## Errata No. X00Z-P-001-01

**Device:** S1D13A03, S1D13A04, S1D13A05.

**Description:** Setting EP4 FIFO Valid bit while NAKing an IN token.

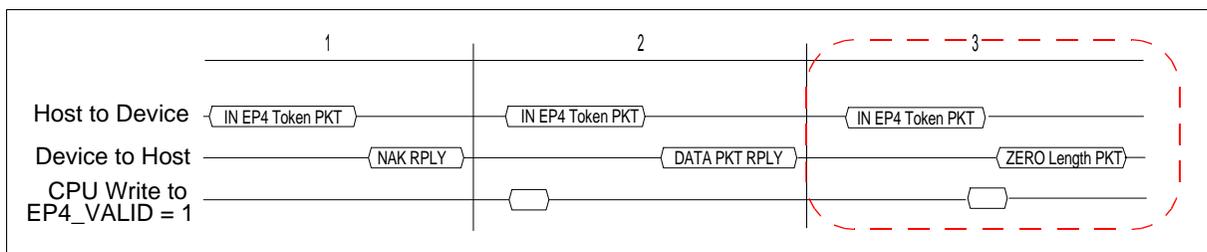
When the S1D13A0x USB controller receives an endpoint 4 IN request and endpoint 4 is not ready to transmit data (REG[402Ch] bit 5 = 0), the response is a NAK packet. If endpoint 4 is toggled to a ready to transmit state just before a NAK response packet is sent, the controller may erroneously send a zero length packet instead. When this happens, the data toggle state will be incorrectly set for the next endpoint 4 data transmit.

The following timing diagram shows the error occurring in section 3.

The first solution involves disabling the USB receiver to avoid responding to an EP4 IN packet. During the time the USB receiver is disabled the EP4 FIFO Valid bit is set.

1. Disable the USB differential input receiver (REG[4040h] bit 6 = 0)
2. Wait a minimum of 1 $\mu$ s. If needed, delays may be added
3. Enable the EP4 FIFO Valid bit (REG[402Ch] bit 5 = 1)
4. Clear the EP4 Interrupt status bit (REG[4004h] bit 4 = 1)
5. Enable the USB differential input receiver (REG[4040h] bit 6 = 1)

Steps 1 through 5 are time critical and must be performed in less than 6  $\mu$ s.
